## Technical Review Memorandum

To: Washington Department of Ecology  
From: Mark Yinger, LHG, Hydrogeologist  
Date: February 3, 2012  
Re: Aspect Consulting Report - Husum/BZ Corner Subarea Rezone

# Proposed Septic Drainfield (2 million square foot area)

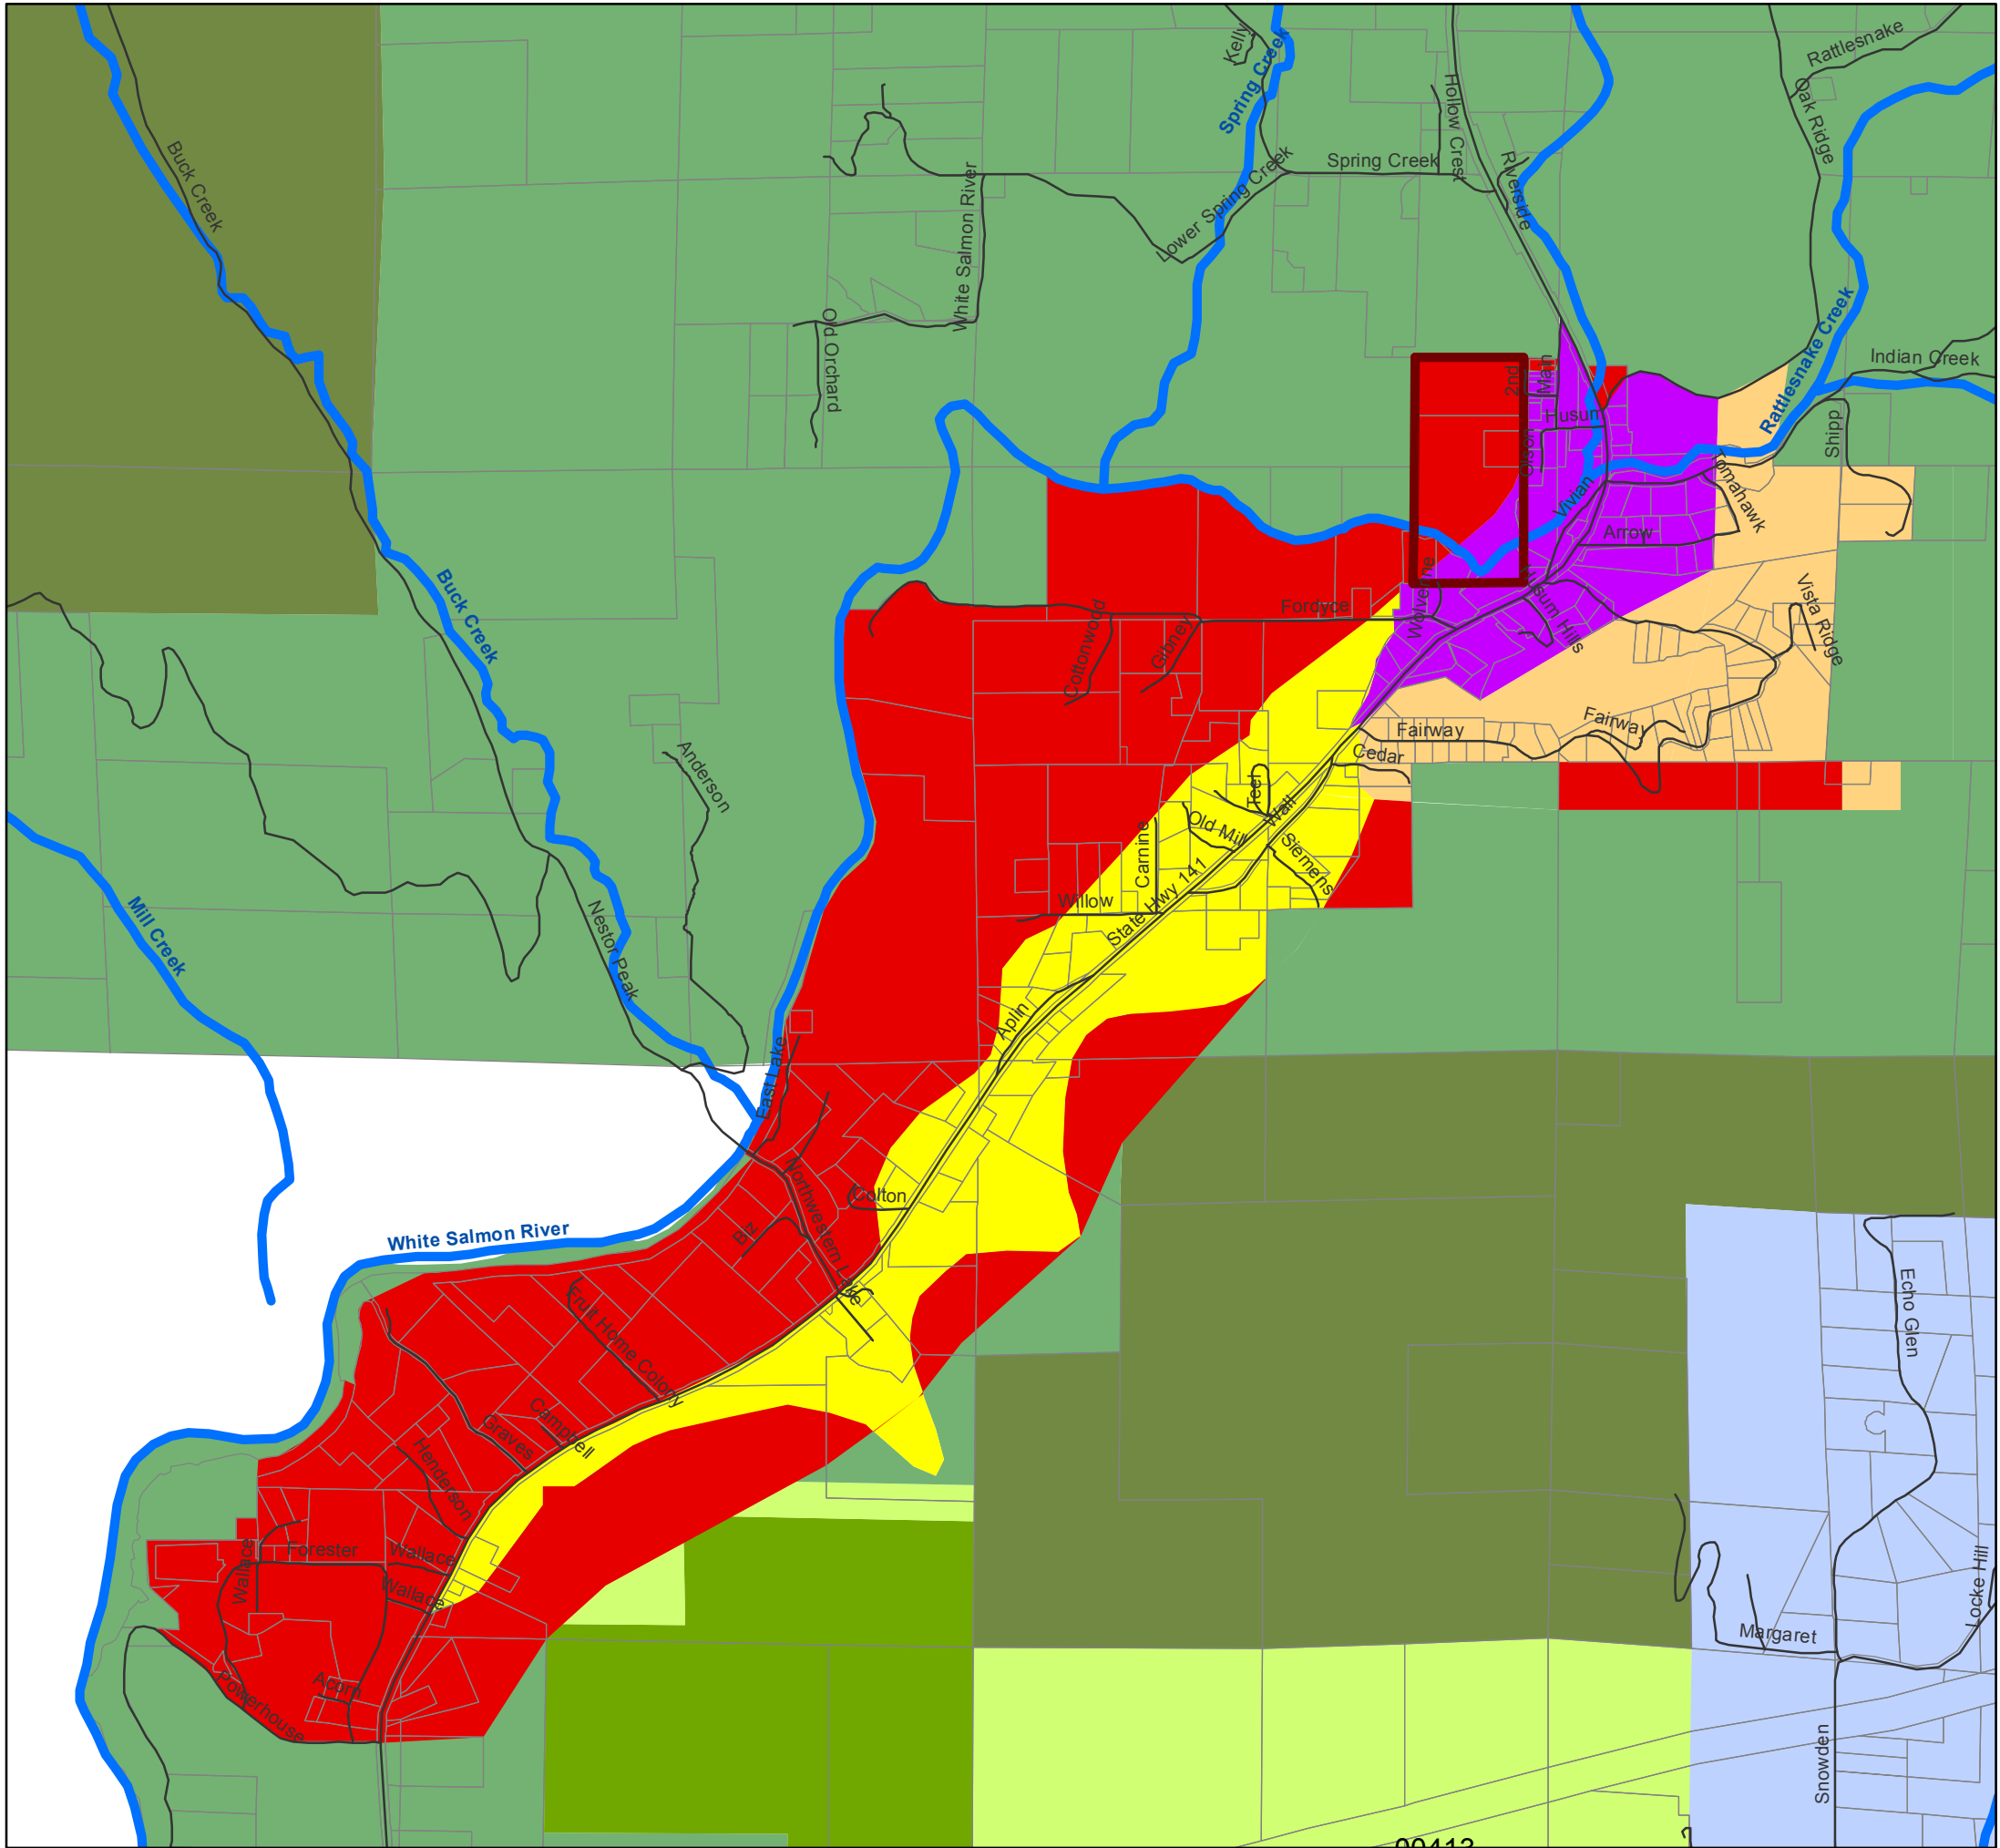
The report presents an evaluation of the impact on groundwater quality due to nitrate concentrations in discharges from sewage drainfields. This presentation is fundamentally flawed, and therefore, should be disregarded. Aspect used a grossly oversized drainfield when applying Ecology’s simple mass balance mixing model to estimate nitrate concentration in groundwater downgradient of a hypothetical community septic drainfield in the Husum RC area.

The Aspect report authors assume the drainfield is the same size as the lot, even in RC zoning where a community sewage treatment system is required for build out at the allowed density. This modification from a default 1,000 square foot drainfield per residence to up to an 87,000 square foot drainfield per residence is a gross misuse of the model and without any foundation in science.

The Aspect report presents artificially low nitrate concentrations. Instead of using a default 1,000 square foot drainfield per residence the Aspect report uses a grossly oversized drainfield that has the result of exponentially increasing dilution of the septic effluent by infiltrating rainfall. The Aspect report presents arbitrary and capricious, clearly erroneous data and conclusions regarding the proposed rezone's impact on water quality.
